Product Safety Recall Bulletin

Bulletin No: 2006-6-01

Subject: Brake Disc and Brake Lever Assembly

2006 Prowler XT Models within the Vehicle Identification Range (VIN) of 4UF06MPV06T300001 - 4UF06MPV86T300781

Fig. 1

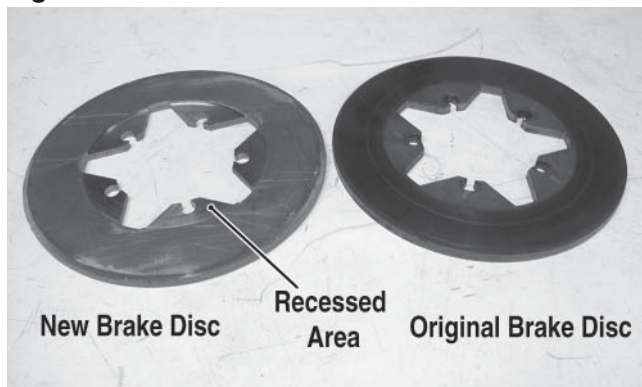
Condition #1: Brake Disc- In some instances, the rear disc may allow one of the brake pads to become misaligned, or in some cases, may be ejected from the floating caliper assembly. If this condition were to occur, it may lead to immediate or premature brake failure.

Condition #1 - Brake Disc

The new brake disc will have a recessed (machined) area on the side facing the rear gear case. The new brake disc will also be secured with yellow shoulder screws contrasted to the original disc which is secured with black shoulder screws. See Fig. 1.

Fig. 2

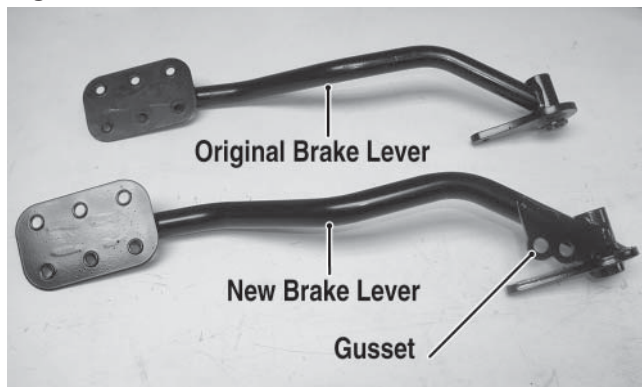
Condition #2: Brake Lever Assembly- In some instances, the brake lever assembly may bend when subjected to a possible emergency load. If this condition were to occur, the bent brake lever assembly may limit the amount of brake lever movement limiting the braking ability.

Condition #2 - Brake Lever Assembly

The new brake lever will have a gusset welded to the backside of the upper section of the brake lever (next to the upper pivot tube). See Fig. 2.
